**PERRY NUCLEAR POWER PLANT**

September 10, 1992  
PY-CEI/OEPA-0159 L

This is a follow up to a conversation you had with Louise Barton on August 13, 1992, in regard to the discharge from an in-plant sump.

See Plan 'A'  
Dwg D 303-021

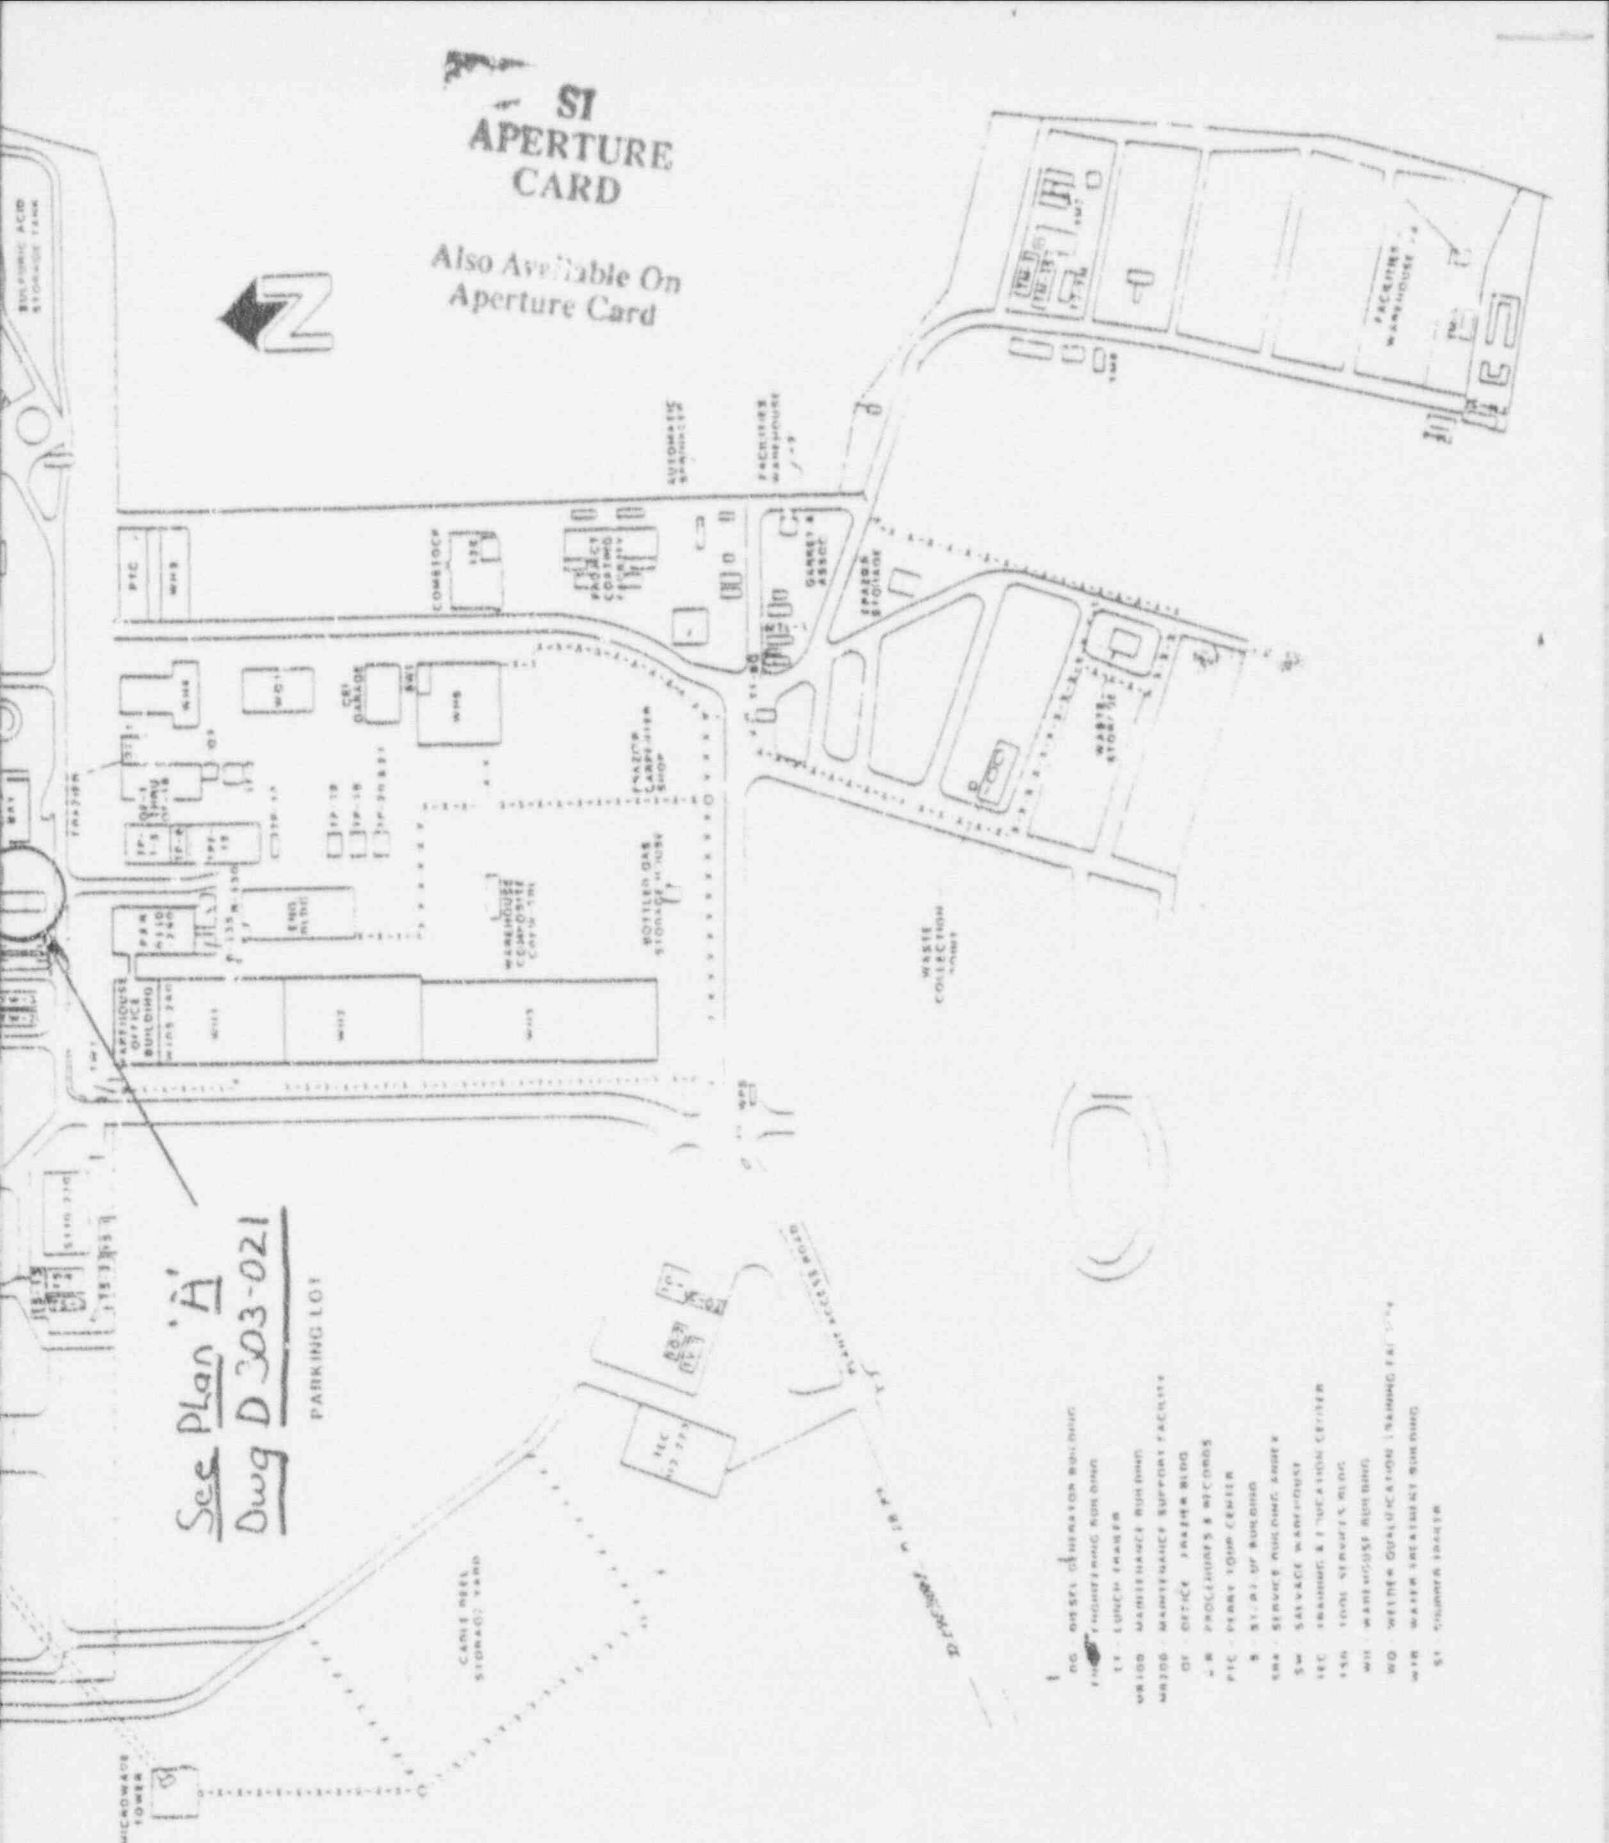
This letter is notification that the discharge will be routed through an oil separator prior to entry into the storm drain system.

The attached drawings show the location of the sump on a general plant layout as well as details of the connection. The new routing will still discharge to the same storm drain system, which was identified in the Perry Plant Stormwater Discharge Permit Application as Outfall 1.
